APPLICATION NO.	FILING DATE	FIRST NAMED INVENTOR	ATTORNEY DOCKET NO.	CONFIRMATION NO.
10/529,225	03/25/2005	Toshiyuki Tanaka	1035-580	8832
23117 7590 07/14/2008 NIXON & VANDERHYE, PC 901 NORTH GLEBE ROAD, 11TH FLOOR ARLINGTON, VA 22203				
EXAMINER				
DUDEK, JAMES A				
ART UNIT		PAPER NUMBER		
2871				
MAIL DATE		DELIVERY MODE		
07/14/2008		PAPER

# Office Action Summary

## DETAILED ACTION

FIG. 4

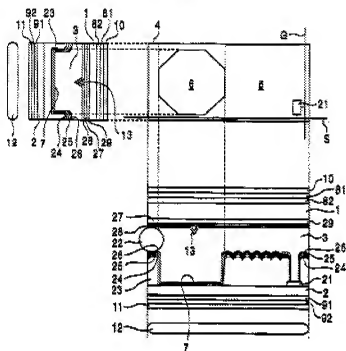
Applicant's arguments filed 1/15/08 have been fully considered but they are not persuasive. The primary reference (939) anticipates the diffusion layer formed only or

substantially only in the reflective regions of the pixels. The figure below clearly teaches such a configuration. See reflection region 5 and diffuser 23.
